STATE OF NORTH CAROLINA DEPARTMENT OF TRANSPORTATION

Minutes of Pre-Bid Conference

- DATE: Tuesday, April 13, 2010
- TIME: 1:00 p.m.
- PROJECTS: Franklin County Bridge No. 38 (MA05012B) Contract Number: DO00060 WBS: 37048
- LOCATION: State Bridge Management's Conference Room, Bridge Management Building, Raleigh, Wake County

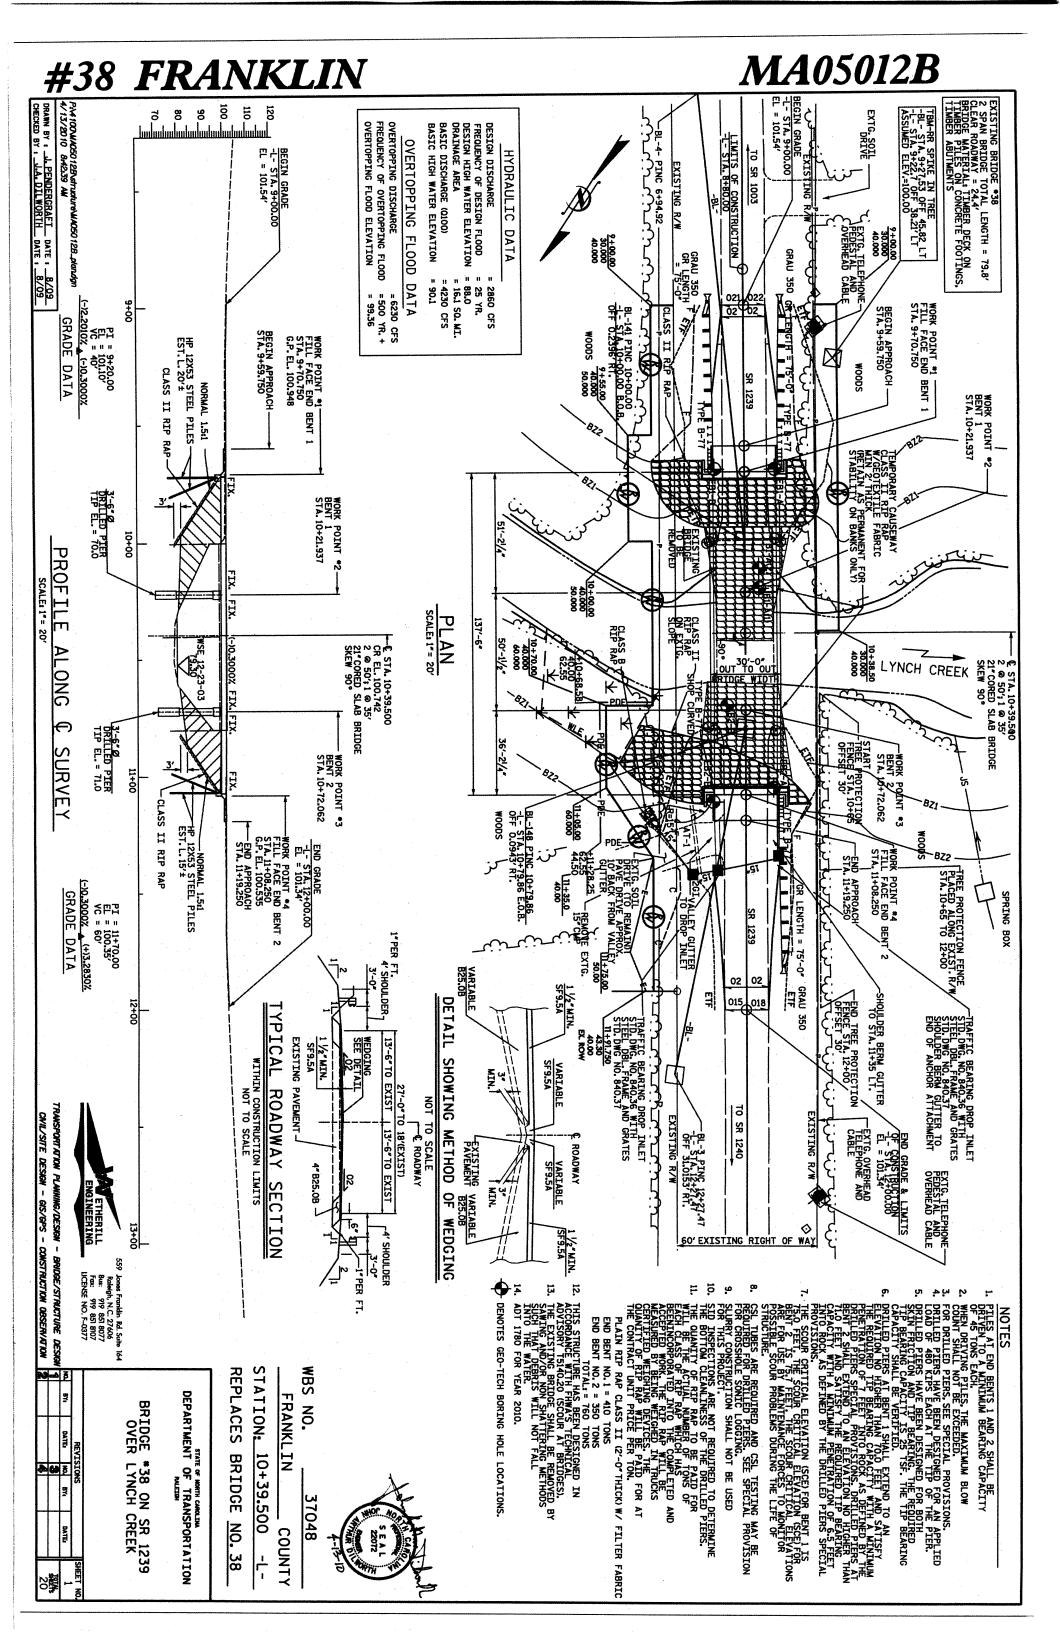
- 2. The "Banking MBE/WBE Credit" section on page 19 of the Bid Proposal Document is not applicable to this contract.
- 3. The 137'-6" length of guardrail shown on drawing sheet no.1 in the north east corner which crosses the existing soil drive was incorrectly shown. Only the shop curved section shown at end of bridge shall be installed at this location. The total length of steel beam guardrail is correct on the Bid Form. An updated drawing sheet no.1 is attached.

- 4. As shown on sheet no.1, portions of the temporary causeway class II rip rap material shall be retained for bank stability only. The remaining in-stream rip rap material shall be removed. This removed rip rap shall be relocated to end bents prior to completion of the project. Payment for relocation of any rip rap shall be incidental to the total cost of class II Rip Rap.
